**Report: TAB REPORT**  
**Function: Test, Adjust, & Balance**  
**Date: 07/03/2025**  
**Completed By: National TAB**

**PROJECT**  
**06-30-25 CHIPOTLE #4957 MANOR, TX**

**Project Issue Information**

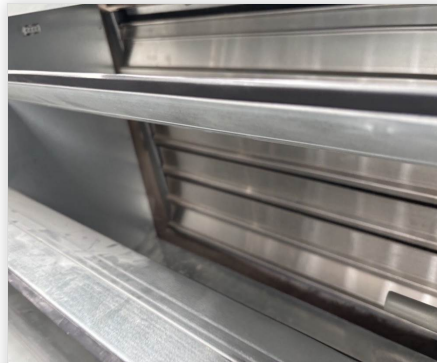
**Issue Name :** RTU Barometric Relief Dampers  
**Description :** Barometric relief dampers are installed incorrectly on the RTUs, allowing air to be pulled in through the outlet. This is causing a significant amount of outside to be pulled in and is pushing the building beyond pressure positive tolerance. Cardboard was placed over the outlet for testing. These dampers need to be installed correctly.  
**Created By :** National TAB      **Assigned To :** National TAB - Brianna Biggs  
**Status :** Open  
**Priority :** Urgent      **Asset Tag :**  
**Originated Date :** 07/02/2025 - Cavin Van - National TAB

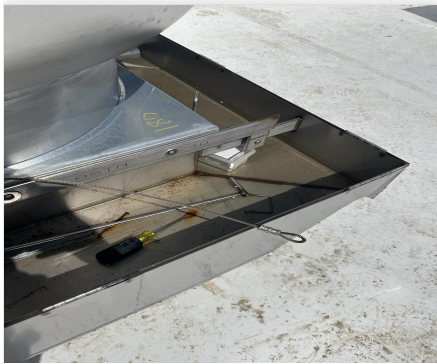
**Issue Name :** Diffuser 2-8  
**Description :** Diffuser is high on airflow. Unable to access damper and decrease airflow. OBD damper is not installed in the face of the diffuser as specified.  
**Created By :** National TAB                      **Assigned To :** National TAB - Cavin Van  
**Status :** Open  
**Priority :** Low                                      **Asset Tag :**  
**Originated Date :** 07/02/2025 - Cavin Van - National TAB

Asset: HD1

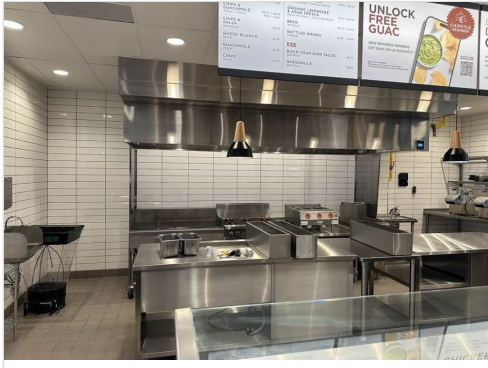
CORE #01 FAULT PRESSURE SWITCH FAULT
